UNITED STATES PATENT AND TRADEMARK OFFICE

APPLICATION NO.	FILING DATE	FIRST NAMED INVENTOR	ATTORNEY DOCKET NO.	CONFIRMATION NO.	
10/737,330	12/17/2003	Michael Anthony Zerillo	7560		
7590 12/21/2005			EXAMINER		
MICHAEL A. ZERILLO 15821 E. JERICHO DR.			HAWK, NOAH CHANDLER		
	ILLS, AZ 85268		ART UNIT	PAPER NUMBER	
	,		3637

DETAILED ACTION

Small, Figure 2

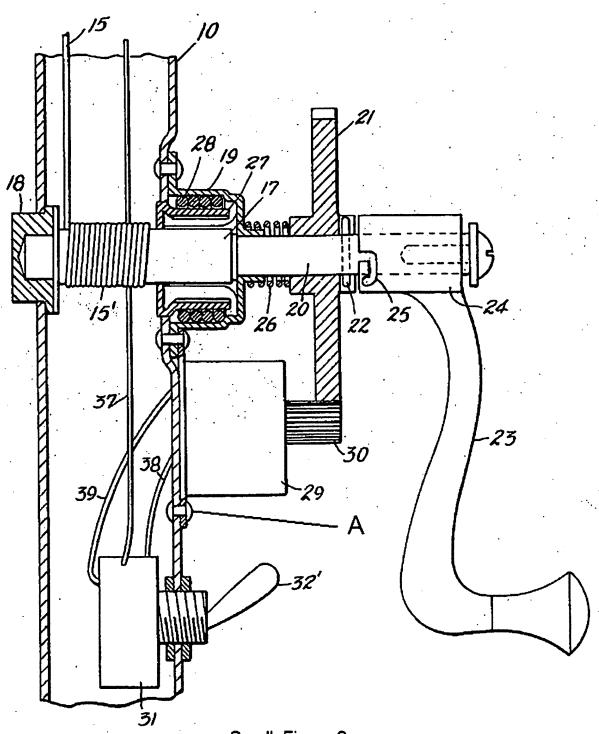
7. Claim 1 is rejected under 35 U.S.C. 103(a) as being unpatentable over Lai in US Patent 6182917 in view of Small in US Patent 2960094. Lai discloses a "retrofit" motor and control kit for umbrellas capable of providing a substitute means to open and close a patio umbrella, the device comprising a housing means (12), a reversible electric motor (21), a means to provide electricity (see Lai, Column 4, lines 14-15), a reel drivingly engaged with the motor (24) and when the electricity is applied to the motor, the motor rotates the reel and the when the electricity is disconnected the motor and reel stop rotating (see Lai, Column 2, lines 38-40), and a length of cable (33) affixable at one end to the reel. Lai further discloses a switch control (10) having two means (see Lai, Column 4, lines 12-15) to connect and disconnect the electricity to the motor and a remote control receiver switch (11) having two means (See Lai, Column 4, lines 12-15) to connect and disconnect the electricity to the motor and a remote control transmitter (See Lai, Column 1, lines 26-28) having means to control the remote control receiver switch. Lai is silent on which direction the motor turns as it relates to the controlling element of the switch control or the remote control receiver switch. However, it would be obvious for the engagement of a first switch means or first receiver switch means in a controlling element such as a switch control or remote control receiver switch to connect electricity to the motor and cause the motor to operate in a first direction of rotation

thereby causing the umbrella to open and for disengagement of a first switch means or first receiver switch means in a switch control or remote control receiver switch to disconnect electricity from the motor to thereby cause it to stop operating and cause the umbrella to stop opening. Further, it would be obvious for the engagement of a second switch means or second receiver switch means in a controlling element such as a switch control or remote control receiver switch to connect electricity to the motor and cause the motor to operate in a second direction of rotation thereby causing the umbrella to close and for disengagement of the second switch means or second receiver switch means in a controlling element such as a switch control or remote control receiver switch to disconnect the electricity from the motor to thereby cause the motor to stop operating and cause the umbrella to stop closing. Additionally, it would be obvious that the weight of an umbrella canopy and gravity would cause the umbrella to close if not supported by an uplifting force. Lai does not disclose that the opposite end of the cable is affixable at the opposite end to the yoke of an umbrella, nor does he disclose a means to affix the housing to the mast at a location to thereby establish control of the yoke of the patio umbrella or that the motor is affixed to the housing. Small discloses a motor device for an umbrella, the device having a cable (15) affixed at one end to a reel (17), the opposite end of the cable being affixable (see Small, Column 1, lines 50-54) to the yoke (13) of a patio umbrella. Small also discloses a means (A) to affix the housing to the patio umbrella at a location to thereby establish control of the yoke of the patio umbrella and that the motor (29) is affixed to the housing (best seen in Small, Figure 2). It would have been obvious to one of ordinary skill in the art at the time

of invention to modify the device of Lai by using a cable attached at an opposite end to the yoke of the patio umbrella, to use means to attach the housing at a location to thereby establish control of the yoke of the patio umbrella and to affix the motor to the housing in order to ensure that the motor is in control of the operation of the umbrella and that it is firmly attached at a convenient position to the umbrella. Please note that the limitations "thereby the motor and control kit substitutes for the function of manually hand lifting and lowering the yoke and controls the canopy opening means and the canopy closing means of patio umbrellas" on page 3, lines 18-20 and page 4, lines 12-14 constitute functional language and have been given no patentable weight.
